Automatic Snow and Ice Sensor
(A9013052)

TECHNICAL BULLETIN

Automatic Snow and Ice Sensor 12" Lead Wire

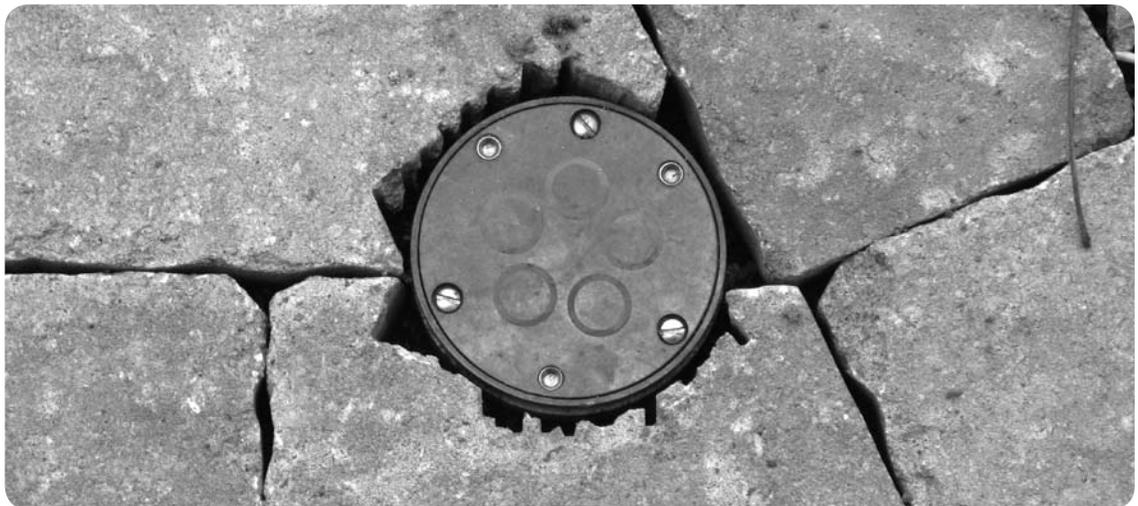
Sensor shorts out, providing a high-temperature reading and preventing a snow melt call.

The 12" lead wire on the original sensor was too short, requiring a connection in the non-waterproof cup. When the cup fills with water, it shorts the connection, providing a high-temperature reading. This condition can lead to communication issues for both the Climate Cöntrol Network System and the Climate Cöntrol Multifunction Controller.

Uponor changed the 12" leads to 60'.

Return the Automatic Snow and Ice Sensor for warranty through Uponor's RMA (return materials authorization) process. Note that incomplete returns (missing parts, temporary cover, etc.) or products returned damaged from misuse will be refused.
